IN THE PLANNING COMMISSION OF WOODBURN, OREGON

DR 2010-05)
EXCP 2010-04) FINAL ORDER
VAR 2010-04)

WHEREAS, a request was made by William Pease, PE, representing Wilbur-Ellis Company dba Woodburn Fertilizer, property owner, for a Design Review for a 5,600 square foot enclosure over existing and new liquid storage tanks, an Exception to Street Right-of-Way and Improvement Requirements for Hardcastle Avenue, and a Variance for building setback and wall requirements, and;

Detail from Figure 7-2 of the Transportation System Plan

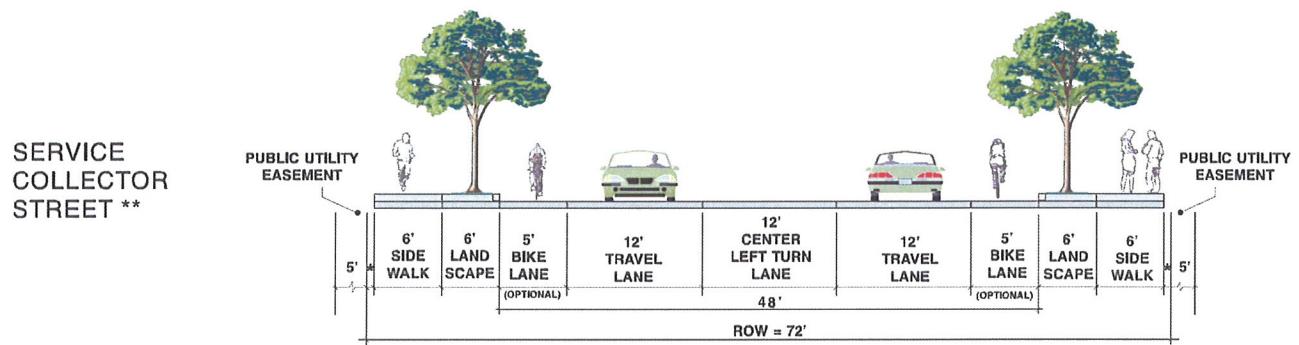
Findings: Hardcastle Avenue is the Boundary Street and also the Connecting Street for the property, as defined in Section 1.102 and shown in WDO Figure 6.12. Hardcastle Avenue is designated as a Service Collector in the Transportation System Plan. The required cross-section for a Service Collector is a 72 foot right-of-way, 36 foot improved driving surface (two 12 foot traffic lanes and a 12 foot center turn lane), 6 foot bike lanes (optional), 6 foot landscape strips and 6 foot sidewalks on both sides. The existing cross-section of Hardcastle Avenue is a 40 foot right-of-way, improved with (north to south) a 4' sidewalk, 2' planter strip, 6" curb, 13' travel lane, 13' travel lane, 6" curb, 2' planter strip, and 4' sidewalk. The site plan shows a 16 foot right-of-way dedication on the north side of Hardcastle Avenue, for a total dedication of 36 feet from centerline. The applicant has requested an Exception to Street Right-of-Way and Improvement Requirements for Hardcastle Avenue, which is discussed in detail below.
